Re: Mary Hodkins Drain Reconstruction

Final Inspection Report

(PRACTICE) Mary Hod	lkins Tile Replacement	
(COOPERATOR)	Becks Hybrids	
(LOCATION) Jackson Twp	SEC. <u>26</u> T <u>20N</u> R <u>4E</u>	
NOTICE TO THE COOPERATOR AND CONTRACTOR  NO REPRESENTATION IS MADE BY THE NATURAL RESOURCES CONSERVATION SERVICE AS TO THE EXISTENCE OR	INDEX OF DRAWINGS	
NONEXISTENCE OF UNDERGROUND HAZARDS. AT LEAST 2 WORKING DAYS PRIOR TO THE START OF CONSTRUCTION, THE	TITLE	SHEET NO
OWNERS OF PIPELINES OR OTHER UNDERGROUND UTILITIES MUST	COVER SHEET	1
BE	Site Location Map	2
<b>2</b>	Plan View and Construction Notes	3
E E	Tile Profile	4
	Manhole Detail	5
CONSTRUCTION DATA	Casting Detail	6
LAYOUT BY:	Road Cut Detail	7
DATE:	Subsurface Drain Install Specifications	8-9
CONTRACTOR NAME AND ADDRESS:	Plan for Existing Block Chute	10-11

MARY HODKING DRAIN 3-9-2012 BECK'S HYGRID RECONSTRUCTION PLANG-PEVIEW W/KENT WARD

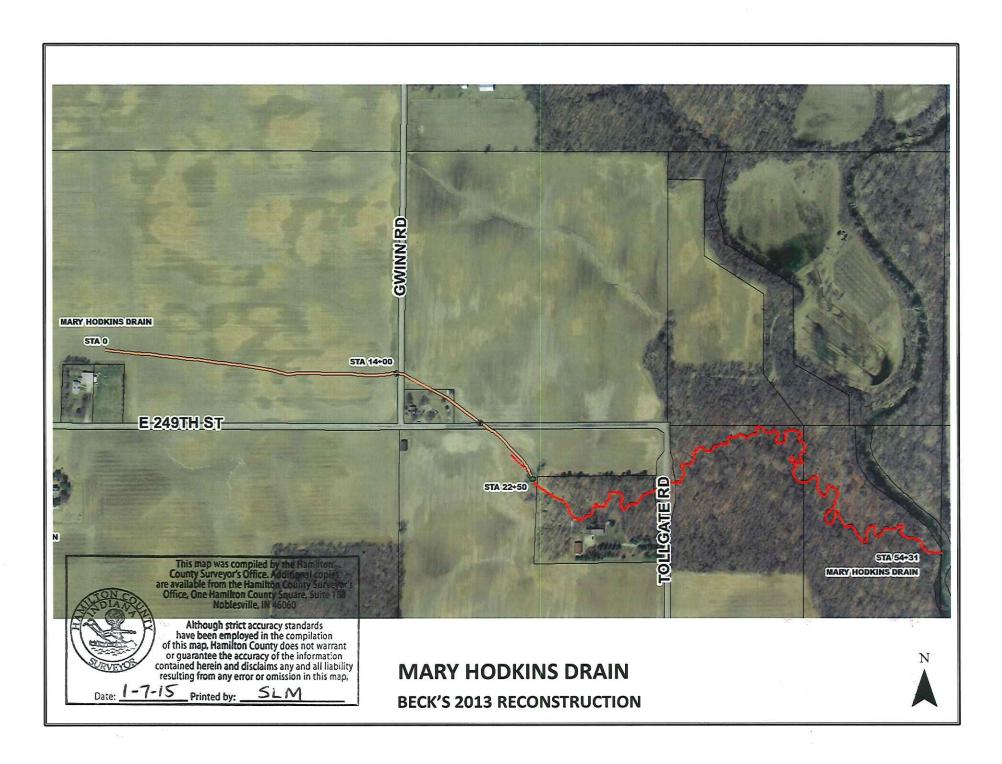
The tile west of Gwinn Road was first installed in the incorrect location. After meeting with personnel from Beck's Hybrids, the tile was reinstalled in the correct location per the legal description.

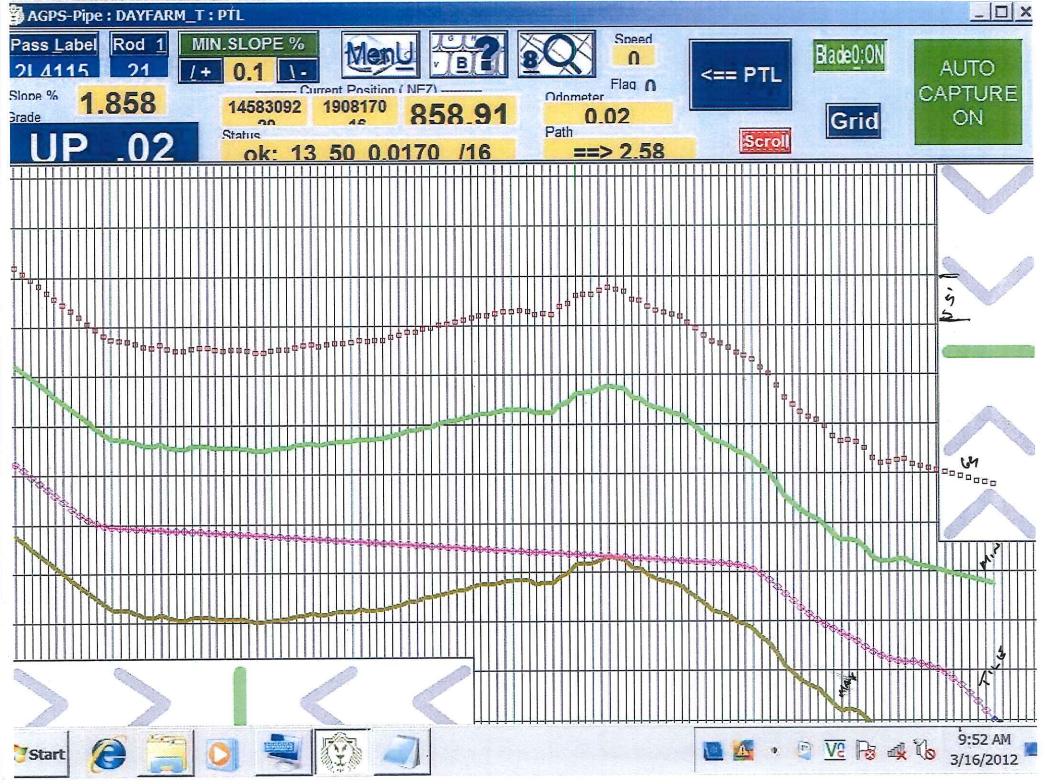
ASSESSED SHED -

CHECK TOPO 5. OF 249TH

- NO VACATION OF EXISTING TILE W OF GWINN ROAD
- WART 10 PLANNED W/OF GWINN TOAD?
- JINE RUN TO GRIMES PROPERTY
- CHECK-DO THEY HAVE LETTERS FROM MARSHALLE
